Florida Department of Environmental Protection

April 30, 2008

RE: Endangered Species Act Section 7 Consultation on Proposed Revision to the
Interim Operations Plan

Daily Average Salinity at 3 Stations in Apalachicola Bay

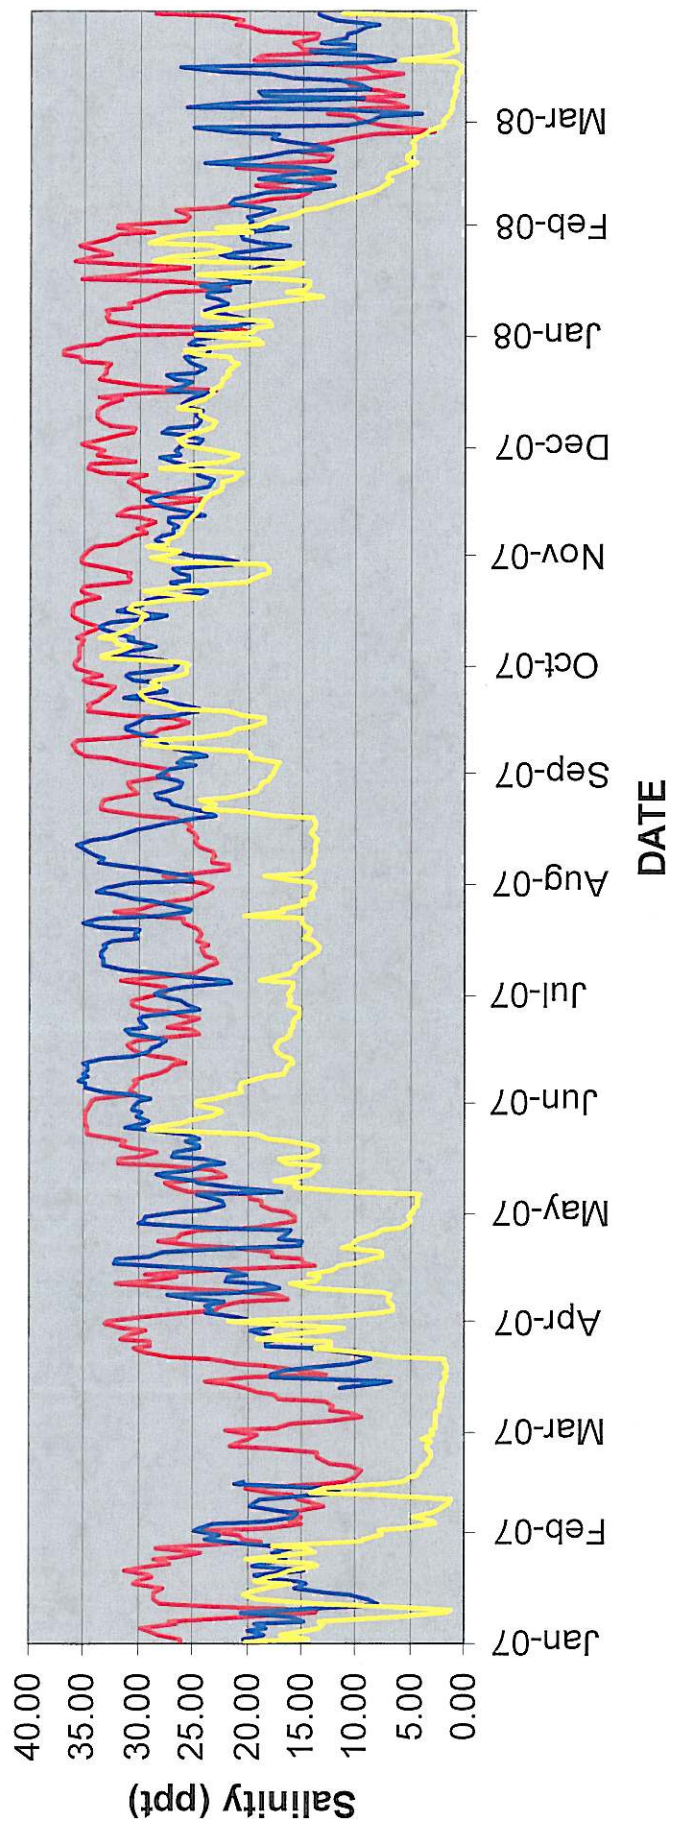
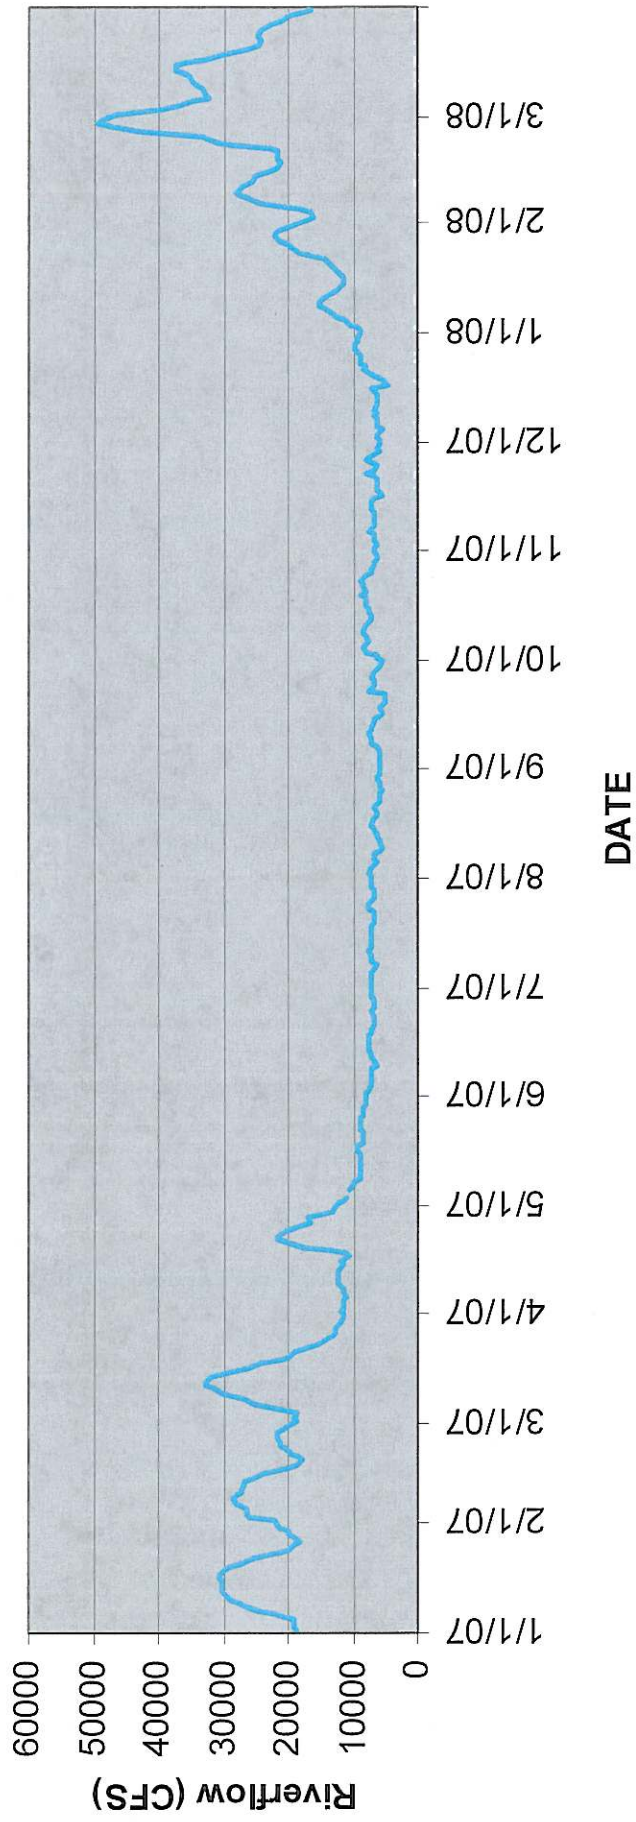
Florida's concerns about the Revised IOP extend beyond its impact on the River to its potentially disastrous effects on Apalachicola Bay. Florida biologists observed high salinities and corresponding oyster mortality throughout the summer of 2007 - at a flow of 5,000 cfs. As you know, salinity and temperature in the Bay are a function of freshwater inflow; the higher the freshwater inflow, the lower the salinity and temperature. The salinity charts attached as Exhibits A, B, C, D, and E show the extraordinarily high salinities experienced last summer, along with a pattern of

increasing salinities corresponding to the Corps implementation of the IOP in spring 2006. You also will see that salinities declined significantly in the early part of 2008 as spring rains returned to the lower ACF Basin. Although it is too early to know, we anticipate these reduced salinities aided the oysters' plight. Yet, a swift reduction in flows for another prolonged period, as dictated by the Revised IOP, would set oyster populations back on a path to decimation. This would starve the Apalachicola River and Bay of freshwater flows needed to keep the ecosystems, species, and economy alive.
